**ADDENDUM NO. 1 -** Distributed via email and posted on the City of Burlingame website at: www.burlingame.org/washingtonplayground

Washington Park Playground, Sports Court, & Picnic Area - City Project Number 85670

Addendum Issue Date: 04/18/2019

C3.0

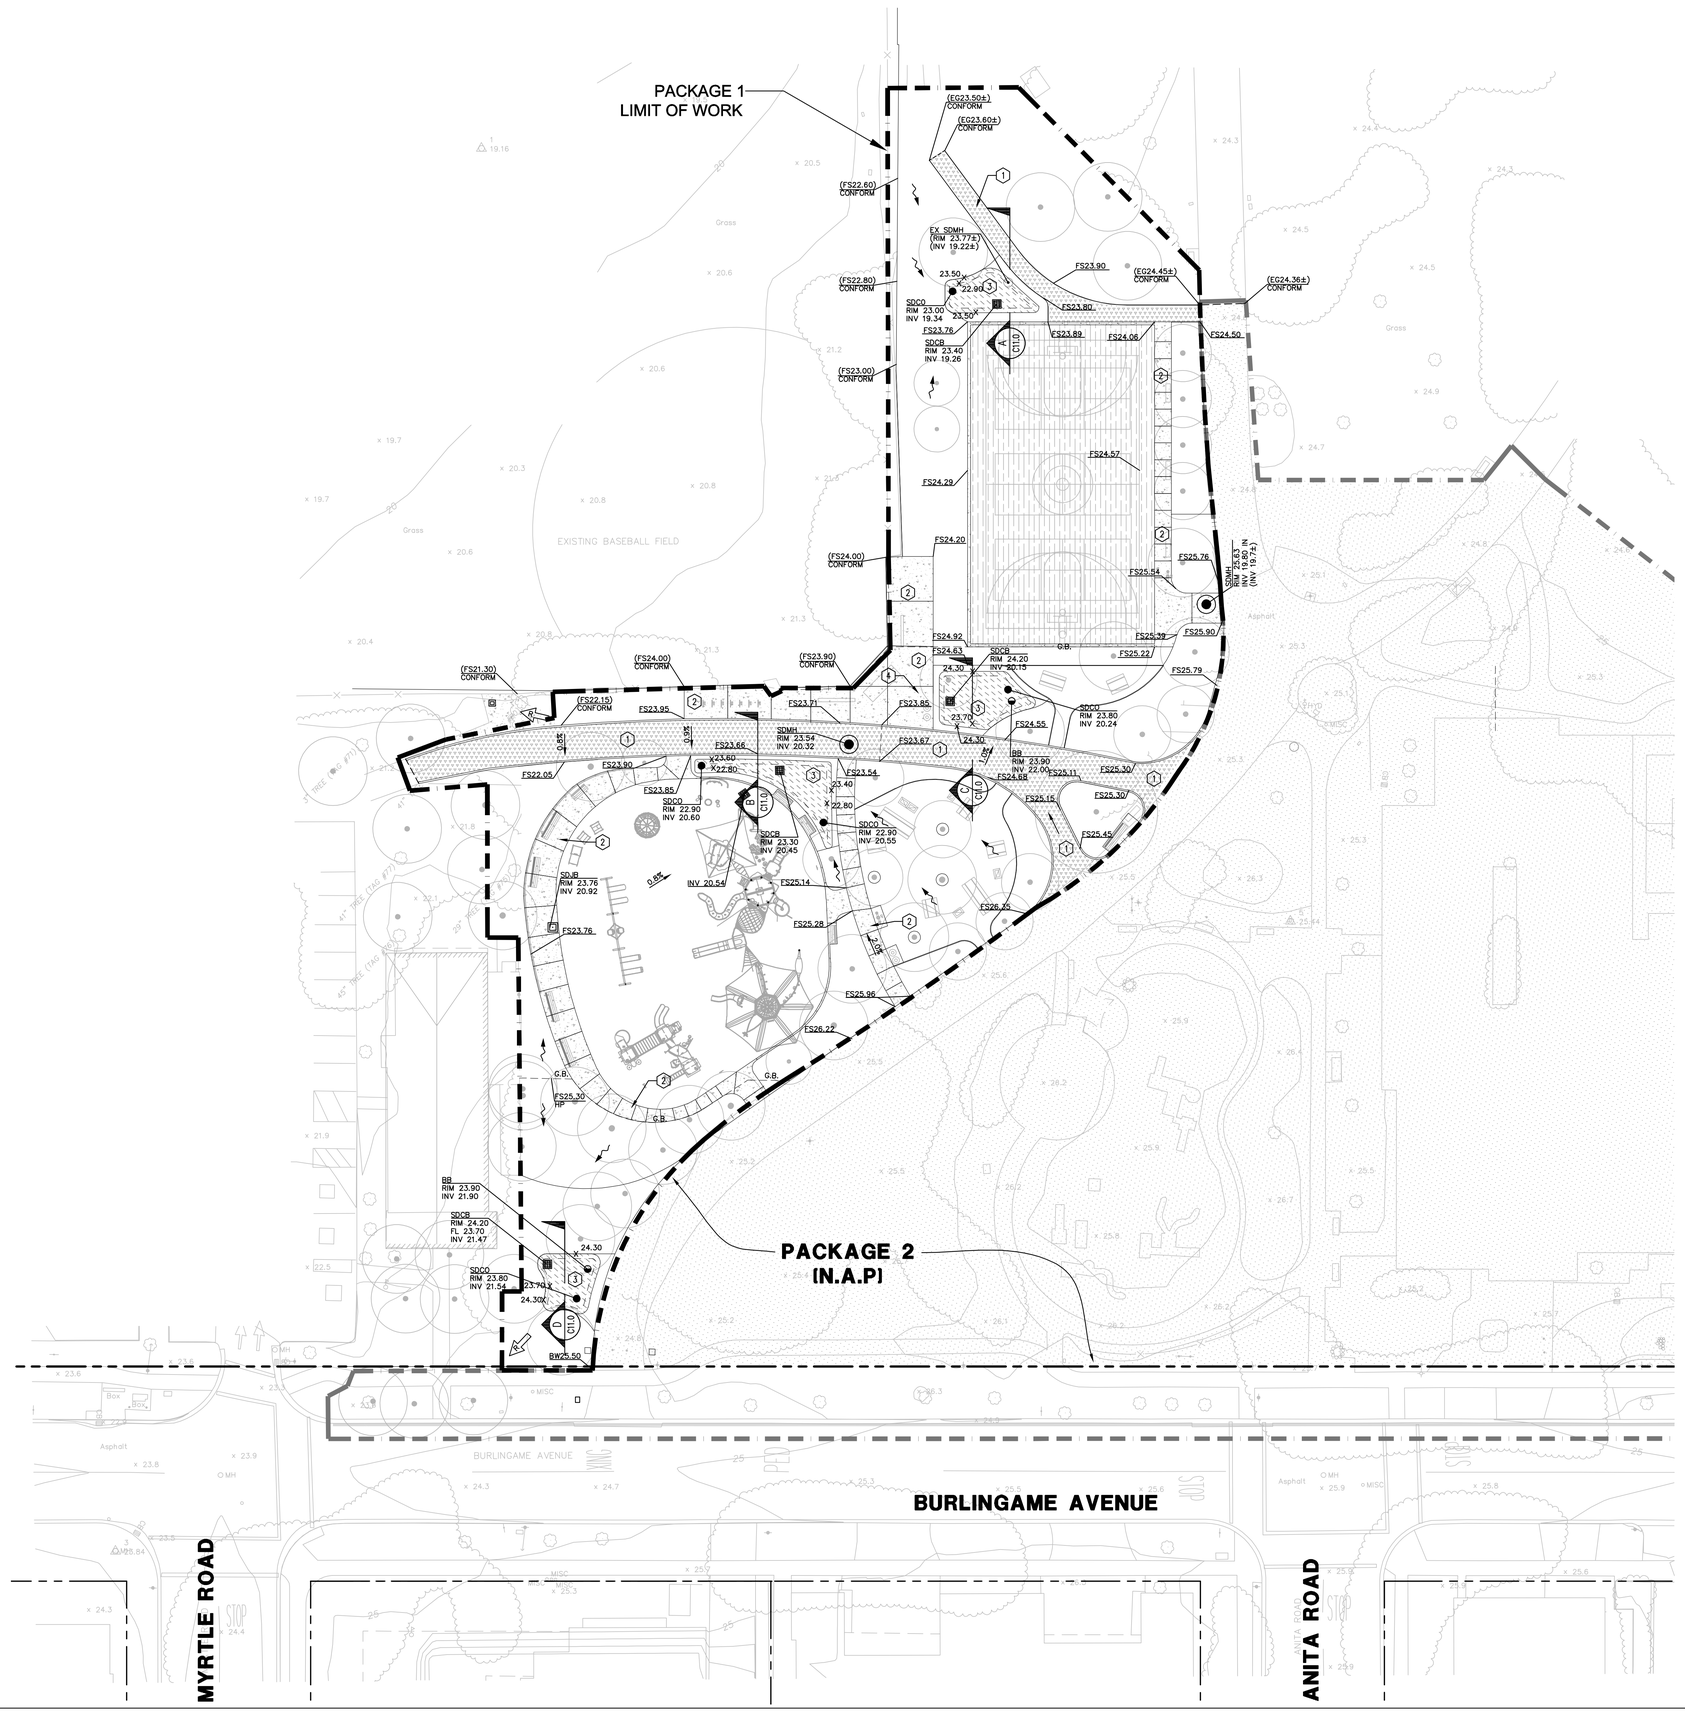
9. **Sheet C1.0:** Per City Public Works Comment, added "Public Works Notes"
10. **Sheet C1.0:** Per Building Department comment, added "constructions hours-onsite"
11. **Sheet C4.0:** Per contractor's question on AC section, revised to 2.5"AC/8" AB CL. II per geotechnical report

C4.0

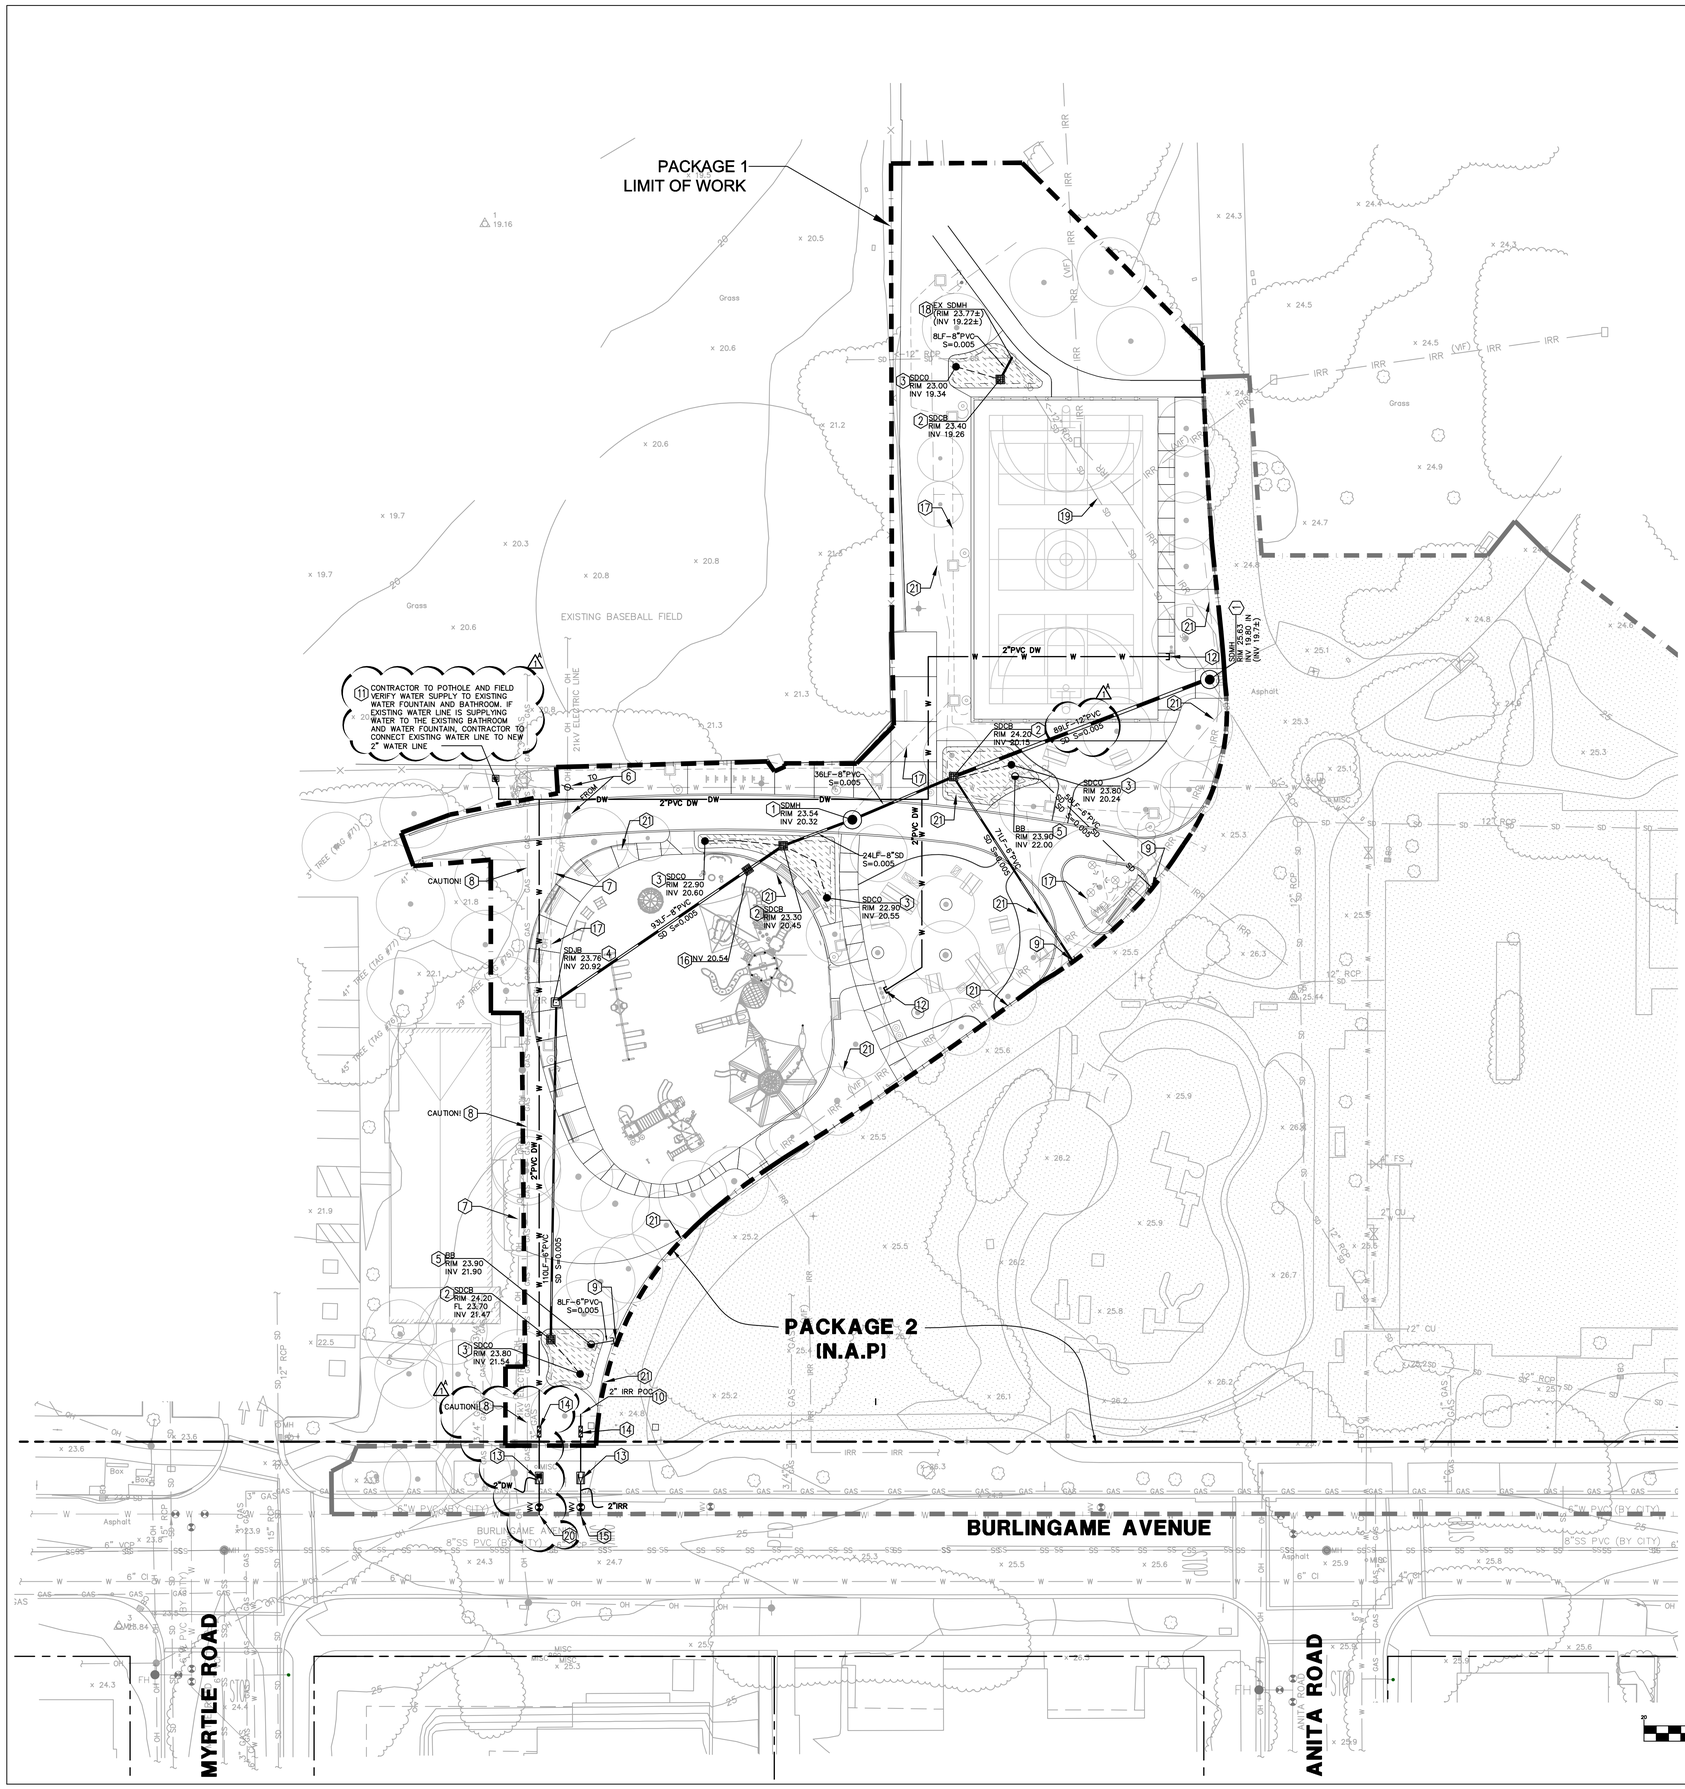
12. **Sheet C5.0:** Per City Public Works comment, the irrigation service to be installed by City. Utility keyed note **number 15 revised**
13. **Sheet C5.0:** Per City Public Works comment, 12" storm drain pipe material revised to PVC

14. **Sheet C5.0:** Added utility keyed note number 18 and 19 for the CCTV of the existing storm drain line and manhole
15. **Sheet C5.0:** Per City Public Works comment, the proposed irrigation lines have been added in the background of the utility sheet. Added utility keyed note number 21

16. **Sheet C5.0:** Per City Public Works comment on the existing water line supplying water to the bathroom and water fountain, a new 2" domestic water service has been added to the utility sheet to supply water to the new water fountains. A note has been added to the utility plan for the contractor to pothole and field verify the water supply to the bathroom and the existing water fountain.

CONTRACTOR TO PROVIDE LOGISTICS PLAN FOR THE CONSTRUCTION PHASE. LOGISTICS PLAN TO BE SUBMITTED TO THE CITY OF BURLINGAME FOR REVIEW AND APPROVAL. LOGISTICS PLANS TO INCLUDE PEDESTRIAN ACCESS TO THE PORTION OF THE PARK TO REMAIN OPEN, ACCESS TO THE EXISTING BATHROOM AND BASEBALL FIELD.

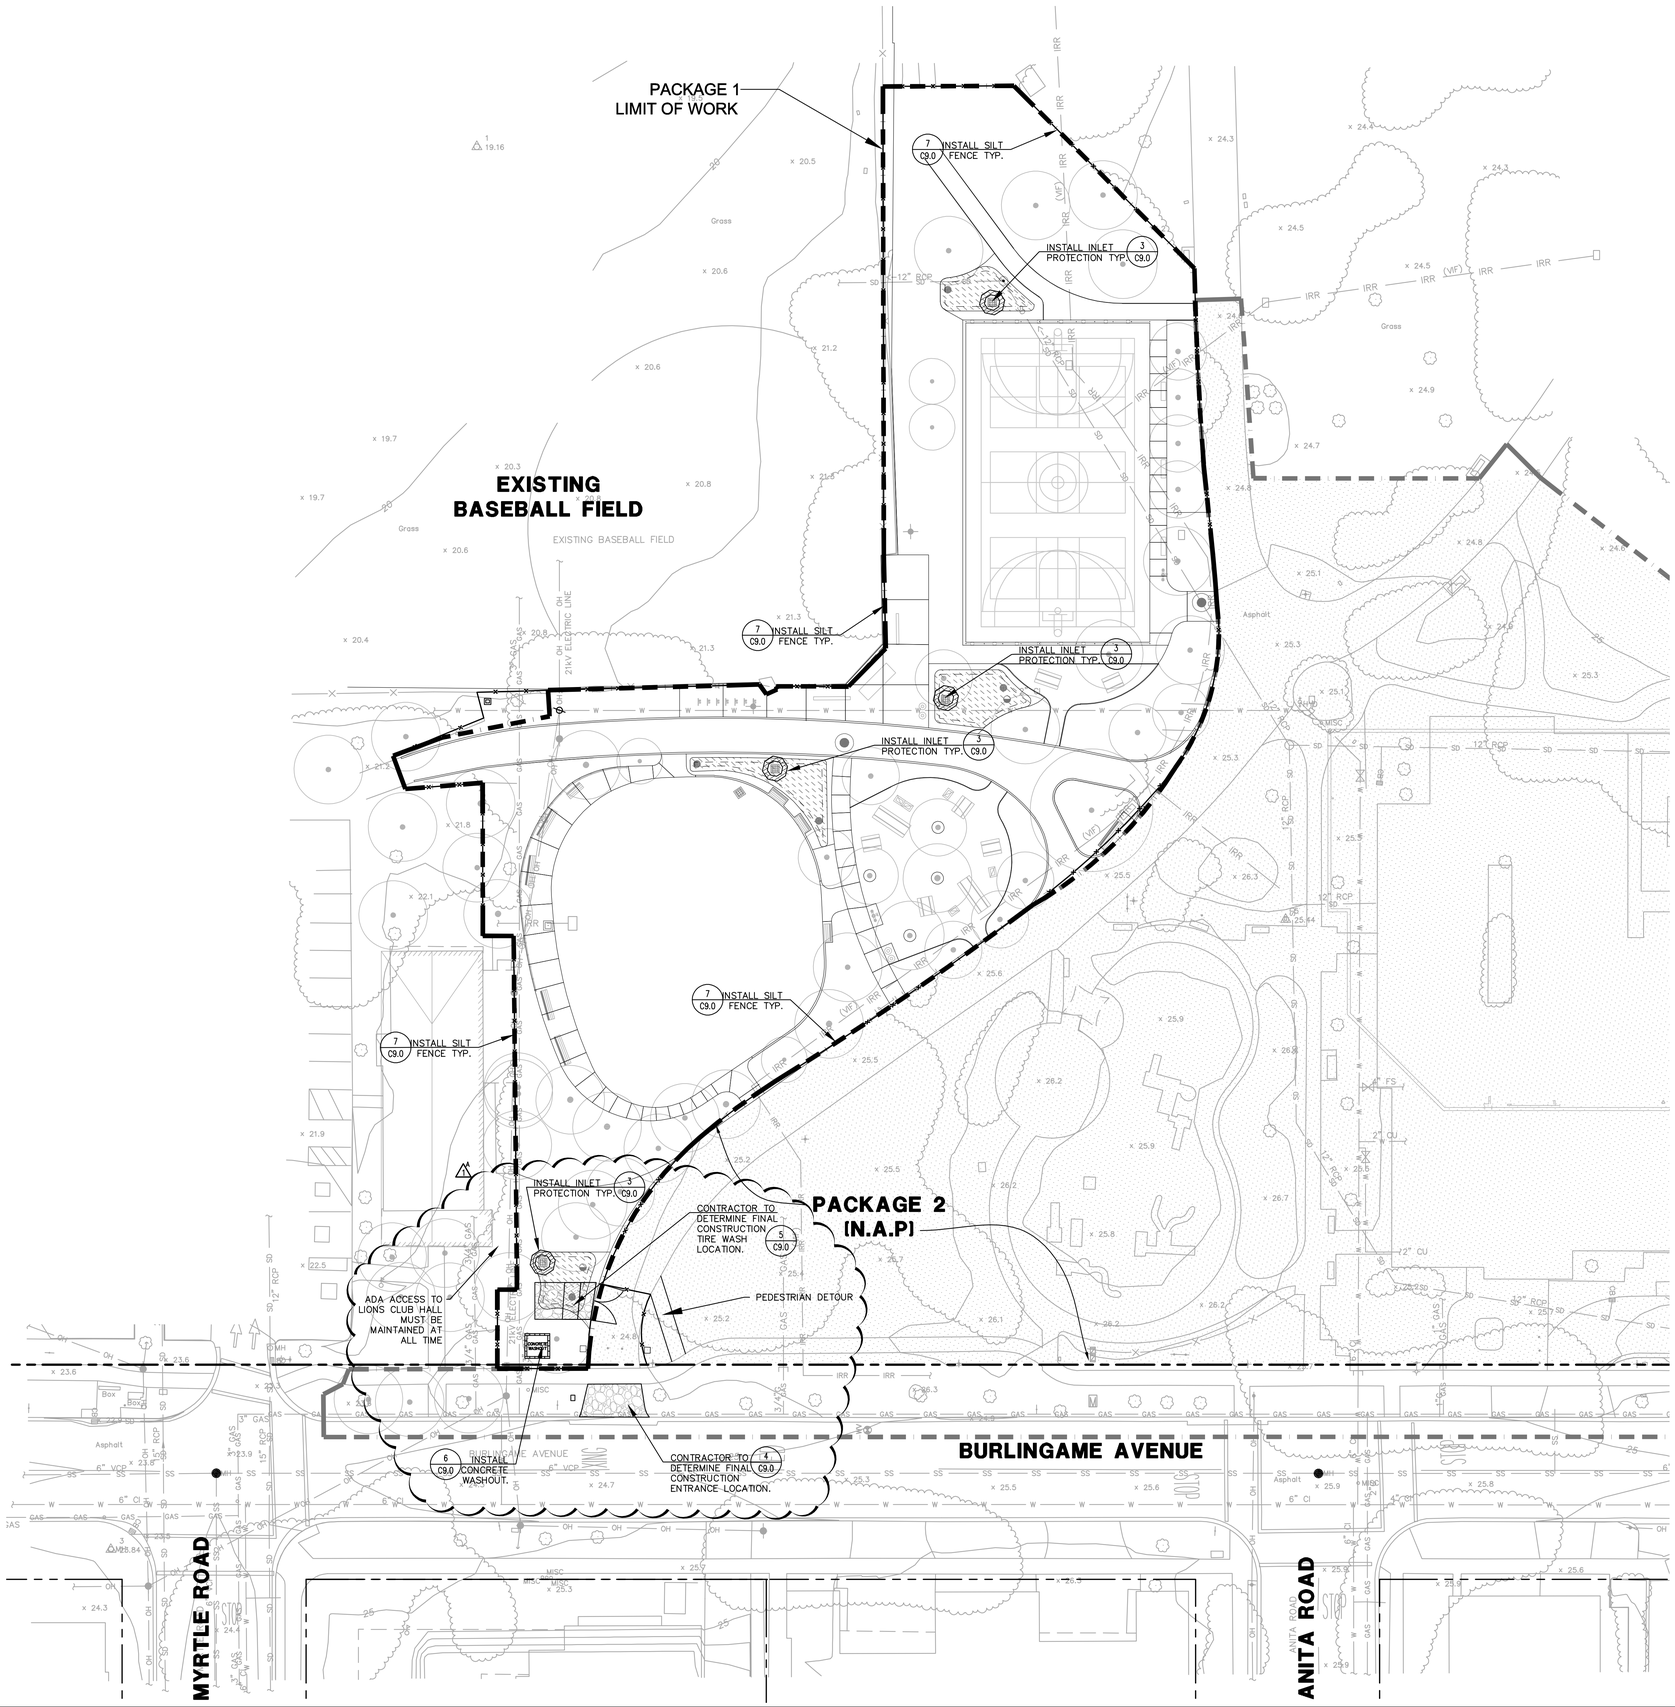
17. **Sheet C6.0:** Per City storwmater comment, added a note on sheet C6.0 to stencil storm drain inlets with "No Dumping-Flows to Bay"
18. **Sheet C8.0:** Per City Public Works comment, a note added "ADA Access to Lions Club Hall must be maintained at all time"

19. **Sheet C8.0:** Per City Public Works comment about providing ADA access to Lions Club, pedestrian access to the remaining of park, bathroom and baseball field, a general note added to sheet C8.0 "Contractor to provide logistics plan for the construction phase. Logistics plan to be submitted to the City of Burlingame for review and approval. Logistics plan to include pedestrian access to the portion of the park to remain open, access to the existing bathroom and baseball field"
